**METROPOLITAN GOVERNMENT OF NASHVILLE AND DAVIDSON COUNTY**

**STAFF RECOMMENDATION**  
**2306 White Avenue**  
**January 20, 2016**

**Application:** Alterations; New construction – addition  
**District:** Woodland in Waverly Historic Preservation Zoning Overlay  
**Council District:** 17  
**Map and Parcel Number:** 10514022900  
**Applicant:** James Kennon, Kennon Calhoun Workshop  
**Project Lead:** Melissa Baldock, [melissa.baldock@nashville.gov](mailto:melissa.baldock@nashville.gov)

<p><b>Description of Project:</b> Application is to alter the siding, windows, and roof material on the historic structure and to construct a side porch and rear addition.</p> <p><b>Recommendation Summary:</b> Staff recommends approval of the project with the following conditions:</p> <ol style="list-style-type: none"><li>1. Staff review the condition of the historic wood siding once the non-historic siding has been removed to assess if any part needs to be replaced;</li><li>2. Only the window sashes be removed where windows are to be replaced on the side facades, in order to preserve the window frames;</li><li>3. Staff approve all new window and door specifications;</li><li>4. Staff approve th

Figure 1. 2306 White Avenue

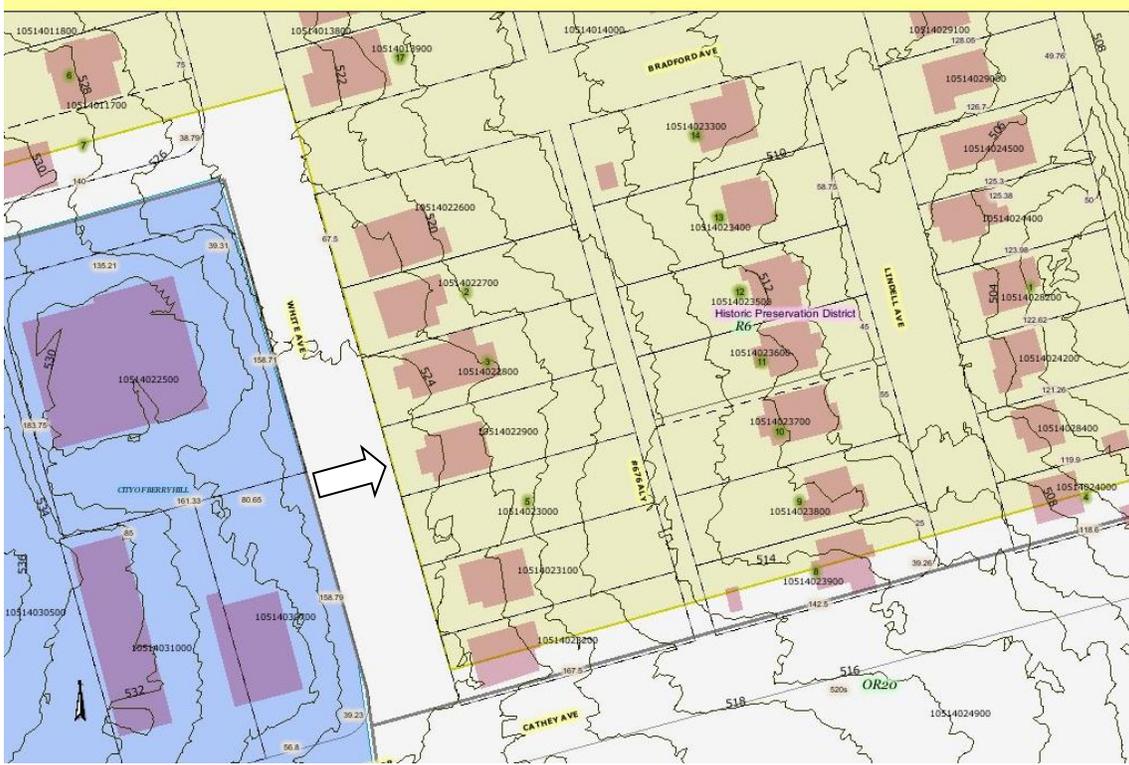
**Background:** 2306 White Avenue is c. 1930 bungalow that contributes to the historic character of the Woodland-in-Waverly Historic Preservation Zoning Overlay (Figure 1).

SITE PLAN

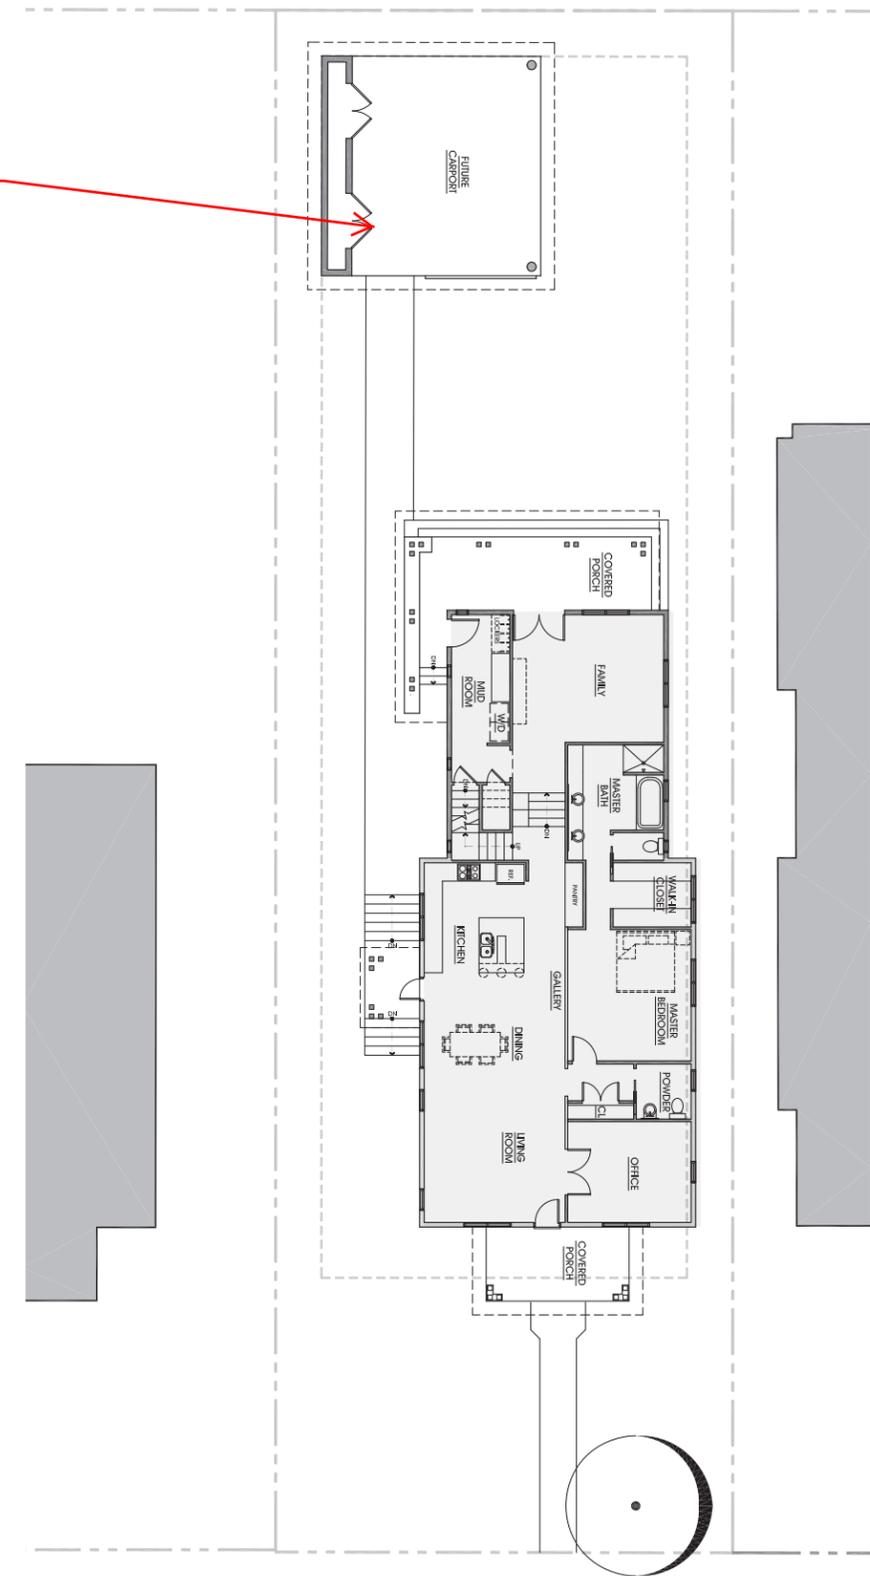
Outbuilding: No outbuilding is proposed as part of this application. The site plan includes potential future garage, but that garage is not currently under the Commission's consideration.

MHZC Note:  
Garage not part of  
current application

Elevations | kennon | calhoun  
scale: 1/8" = 1'-0"  
11 January 2016 | **WORKSHOP**  
architecture design planning management

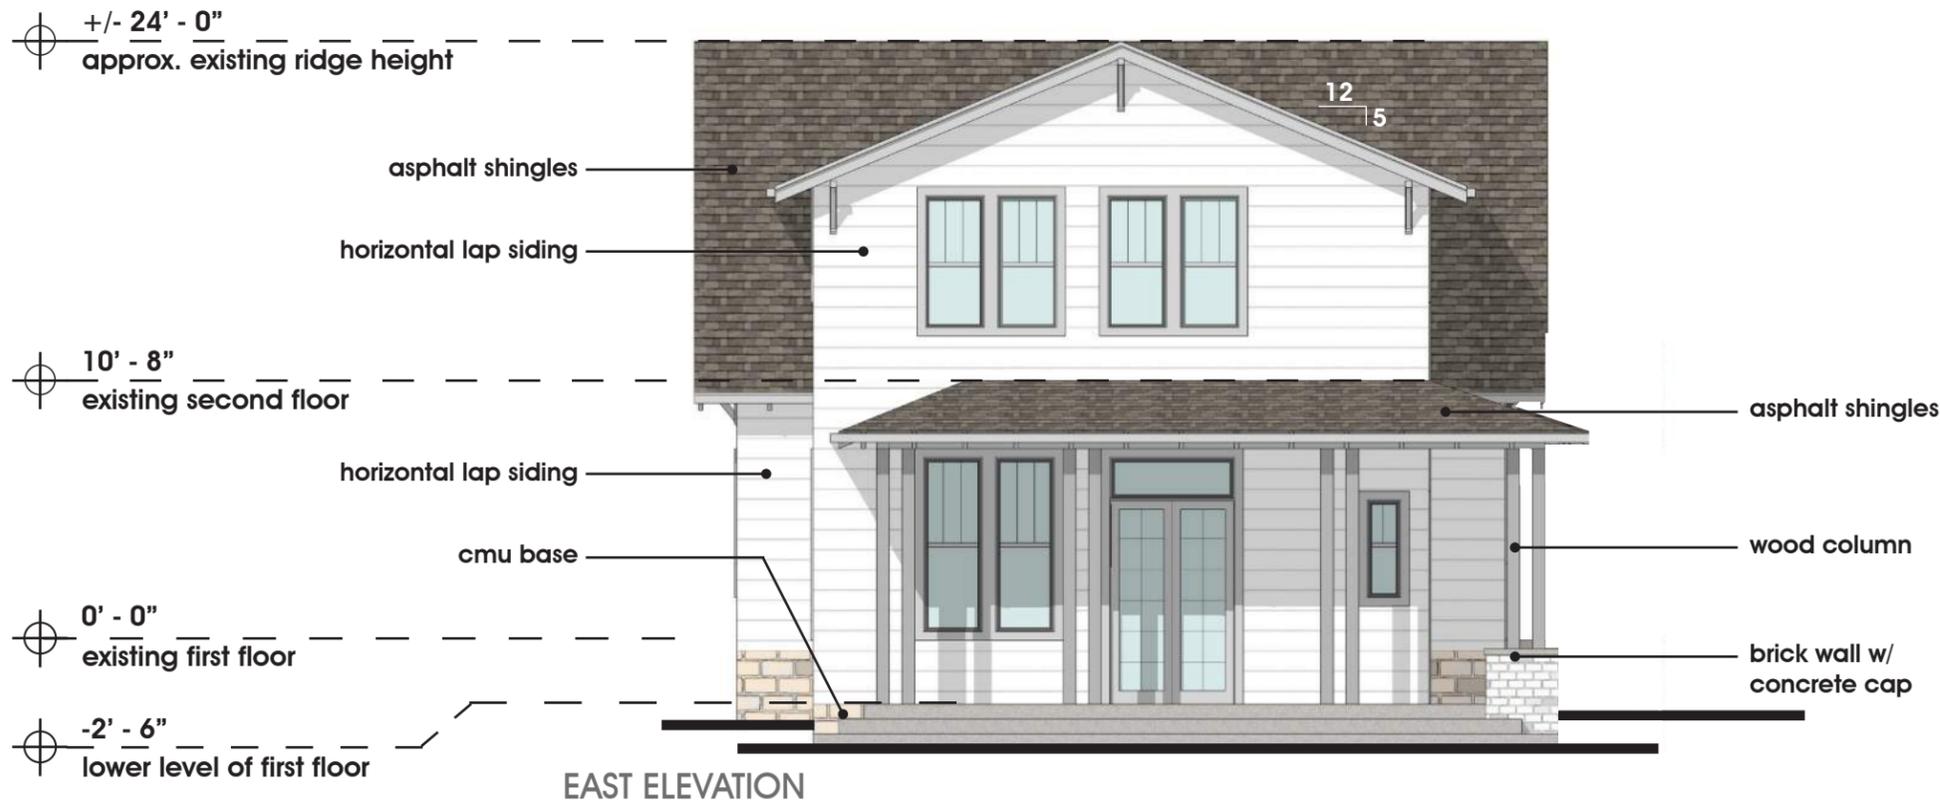
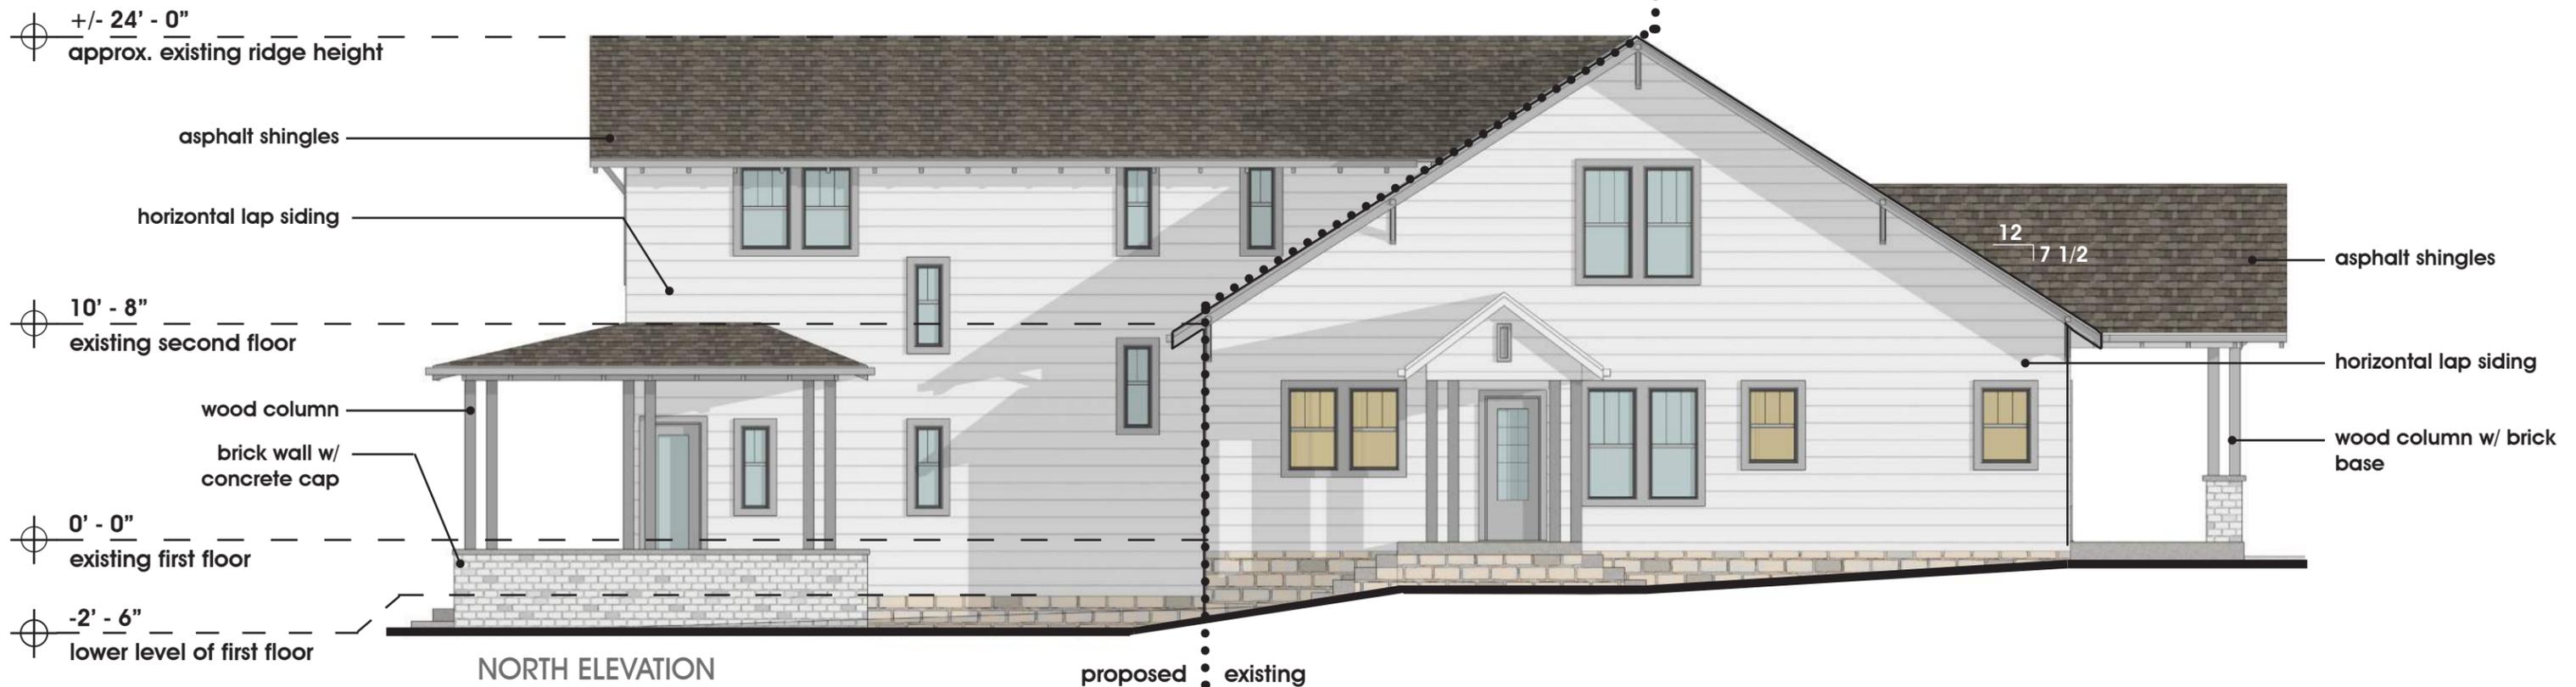
Materials, Texture, and Details and Material Color: The addition will primarily be clad in horizontal lap siding. Staff recommends that the siding be wood or smooth-face cement fiberboard with a maximum reveal of five inches (5"). The trim will be wood or cement fiberboard. The foundation will be CMU block, and staff recommends that it be split face. The window and door materials and model were not specified, and staff recommends approval of all windows and doors. Likewise, staff recommends approval of the asphalt shingle color, material, and texture, and a brick sample for the rear porch wall. The rear and side porch posts will be wood.

Roof Form: The historic house has a side gable roof form with a 7.5/12 pitch. The rear addition has a front-facing gable with a 5/12 pitch. The side porch roof will have a side gable roof with a slope of approximately 8/12. The rear porch will have hipped roof with a slope of approximately 4/12. Staff finds that the proposed roof forms are compatible with the historic house's roof and meet Sections III.B.1. and III.B.2.e. of the design guidelines.

Proportion and Rhythm of Openings: The south side façade does have an expanse of nineteen feet (19') without a window or door opening on its second level. Staff finds it to be appropriate because it is located over forty feet (40') from the front of the house and is inset two feet (2') from back walls of the historic house, minimizing its visibility. The windows on the addition are largely twice as tall as they are wide, thereby meeting the historic proportion of window openings. Staff finds the addition's proportion and rhythm of openings meet Section III.B.2.g. of the design guidelines.

1. Staff review the condition of the historic wood siding once the non-historic siding has been removed to assess if any part needs to be replaced;
2. Only the window sashes be removed where windows are to be replaced on the side facades, in order to preserve the window frames;
3. Staff approve all new window and door specifications;
4. Staff approve the roof shingle material, color, and texture;
5. Staff approve a brick sample;

6. The CMU block for the foundation be split face concrete block;
7. The side porch posts have a cap and a base;
8. The HVAC be located behind the house or on either side, beyond the mid-point of the house; and
9. Staff approve any permanent landscape features, including, but not limited to, fences, parking pads, and walkways.
